ECE/TRADE/WP.7/GE.11/2005/5/Rev.1
9 March 2006

REVISION OF THE UNECE STANDARD FOR
PORCINE MEAT – CARCASES AND CUTS
Chapter 5, Part I

Submitted by the United States of America

FOREQUARTER 4005-4008

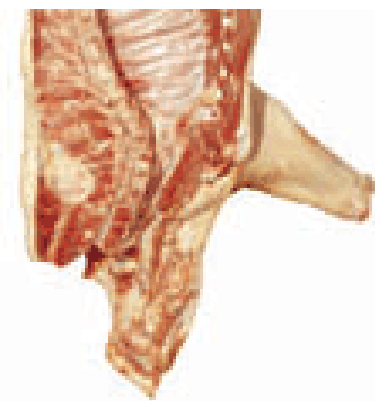
The *forequarter* is derived from a *split carcass side* by a straight cut through the vertebrae at a specified rib number, following the contour of the rib to the ventral portion of the belly. Foot, jowl and cervical/thoracic vertebrae and ribs/intercostals are retained unless otherwise specified.

BELLY 4079 - 4082

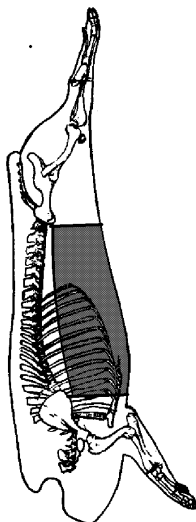
The *belly* (bone in) is prepared from the *middle* by the removal of the *loin*. The skin is retained. Practically all leaf fat shall be removed. The anterior (shoulder) and posterior (leg) ends of the belly shall be reasonably straight and parallel. No side of the belly shall be more than 5 cm longer than its opposing side. The width of the flank muscle (rectus abdominis) shall be at least 25

percent of the width of the belly on the leg end. The fat on the ventral side of the belly and adjacent to the flank shall be trimmed to within 2 cm from the lean. The belly shall be free of enlarged, soft, porous, dark, or seedy mammary tissue.
